Coexistence of PDV proposals with Sensus FlexNet systems

Summary of analysis for FCC

July 24, 2015

Summary of findings

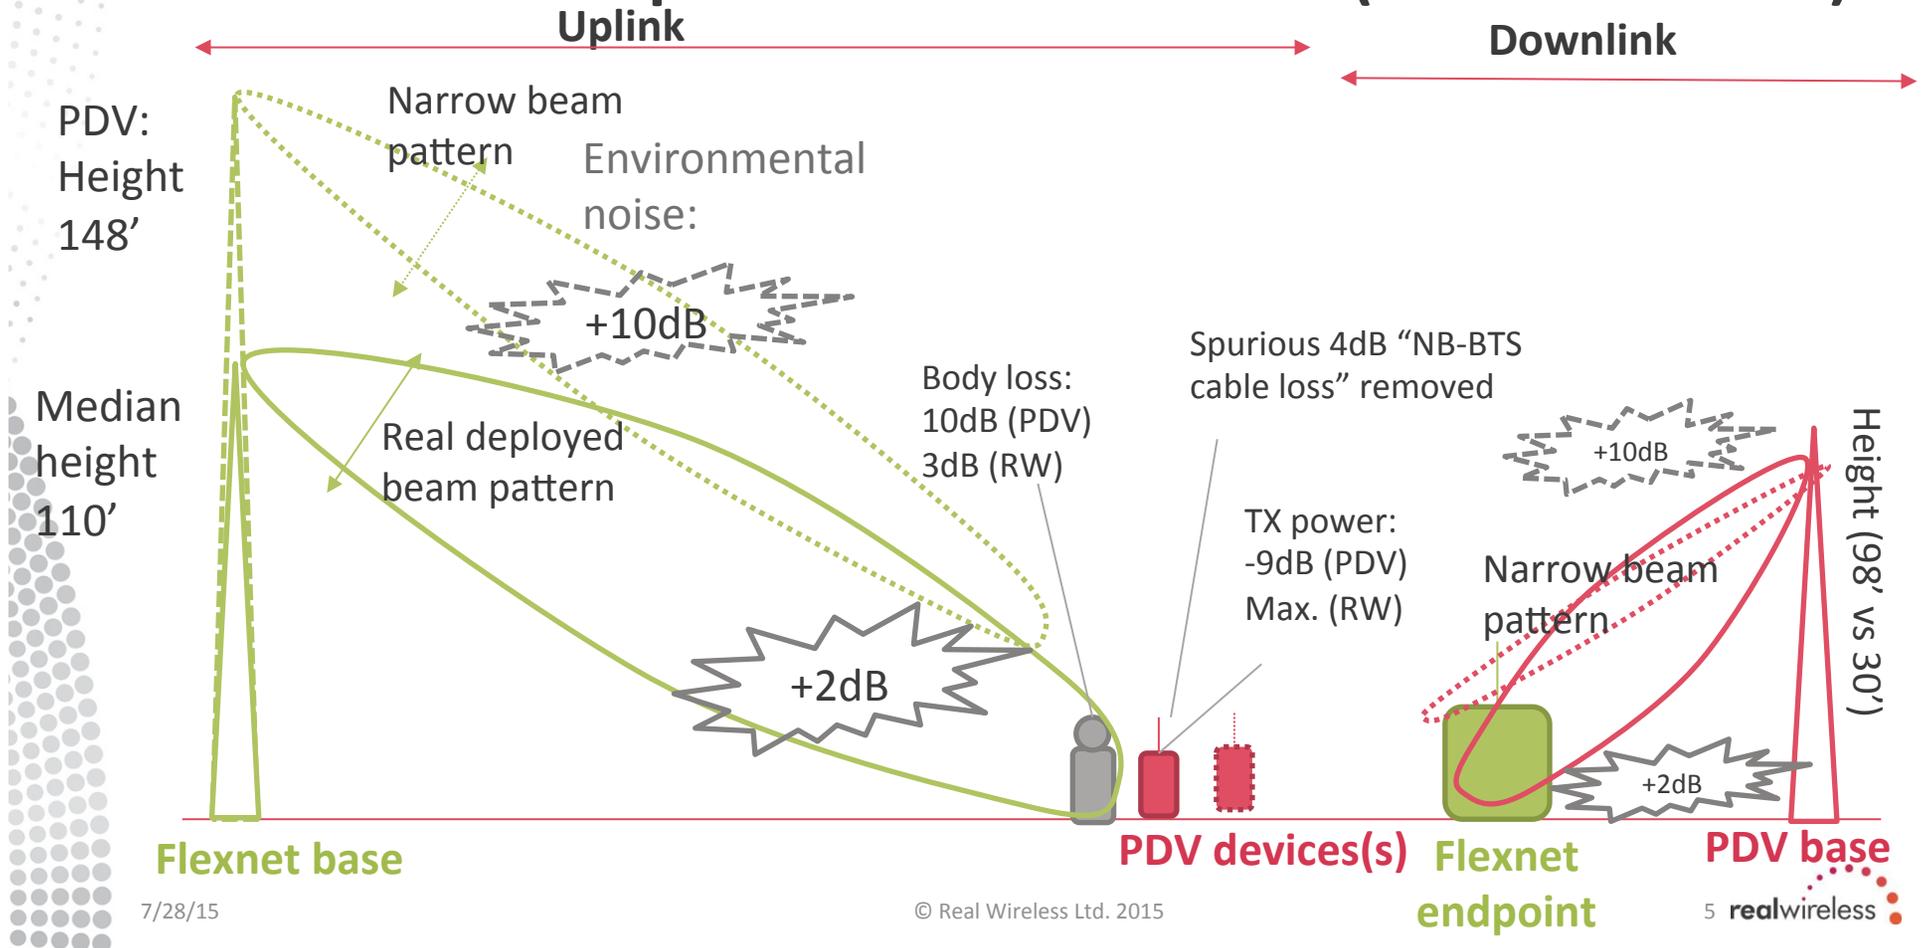
- Our analysis takes a conservative, realistic view of coexistence parameters
- PDV's analysis adopts highly optimistic parameters

Arrows show attenuation needed to protect FlexNet systems

Environmental noise margin

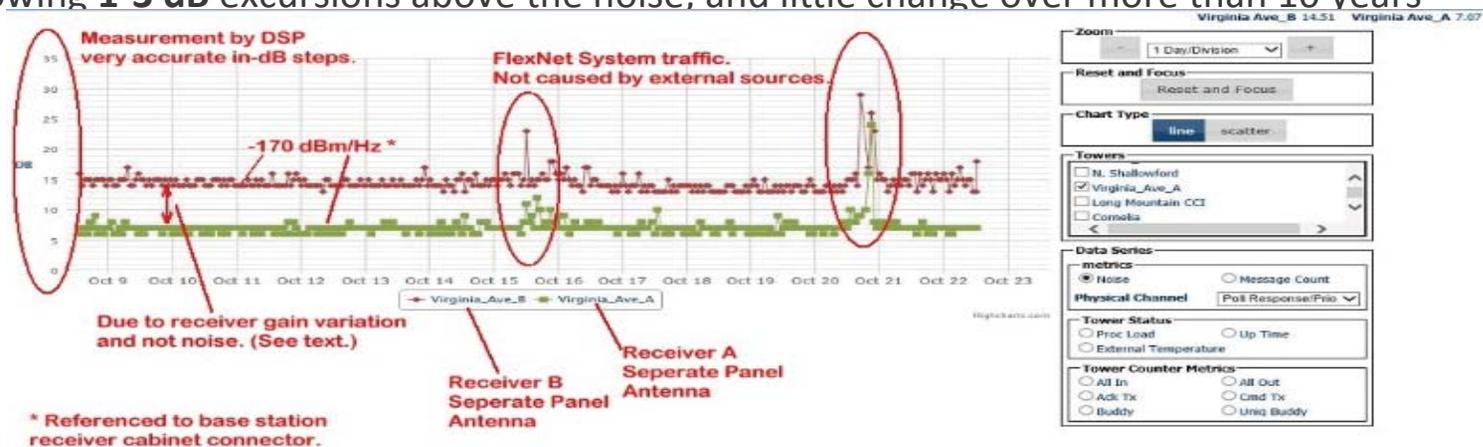
- The basic noise floor seen at a Sensus base station is at thermal noise PSD ($kT = -174\text{dBm/Hz}$) plus the base station system noise figure (4dB based on Sensus data) i.e. **-170 dBm/Hz**
- The noise floor *may* be raised at individual sites by environmental noise
- PDV has included a noise margin of 10dB, resulting in a 9.5 dB noise rise to **-160.5 dBm/Hz** based on their reading of a collection of generalised studies noting: *“studies...were difficult to find...deliver values from a limited amount of samples...had to be extrapolated”* suggesting a low confidence in their chosen value.
- Sensus have made explicit measurements at several base stations over several years showing **1-3 dB** excursions above the noise, and little change over more than 10 years

Impact: 8-10dB higher susceptibility to interference

LTE UE power backoff

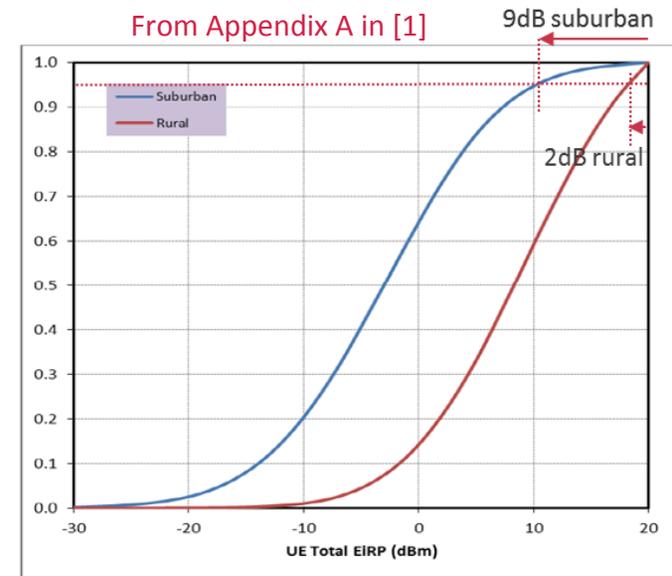
- PDV have assumed that the transmit power of the UE is reduced by **9dB**, citing an NTIA CSMAC report [1] on coordinating satellite Earth stations with LTE
- The calculations related to the statistics of *mobile* UEs distributed over a wide coverage area and many cells.
- They do not capture the impact of interferers with fixed locations, where interference may persist over long periods, transmitting at or close to maximum power
- PDV have chosen the suburban curve. Many FlexNet systems operate in rural areas. The rural backoff value is closer to 2dB
- PDV have chosen the 95% probability level.
- Hence we believe it is appropriate to evaluate interference based on **0-2dB backoff**

Impact : 7-9 dB worse interference

Effect of FlexNet base antenna height

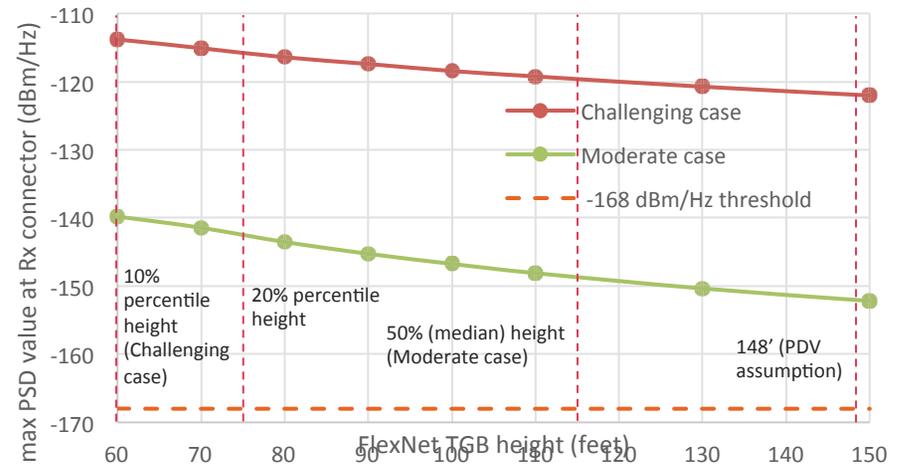
- We have varied the height of the Sensus TGB base station to determine the sensitivity to this parameter
- The graph shows the value of the highest PSD encountered at any distance for a given TGB antenna height
- There is around 10 dB of variation between the PDV assumption and our challenging case (which represents protection of 90% of all Sensus TGBs)
- There is around 5dB of variation between our moderate and challenging cases
- This points to the potential for a site-specific protection level
- However in all cases the PSD remains above the required protection level

Impact :5-10 dB worse interference
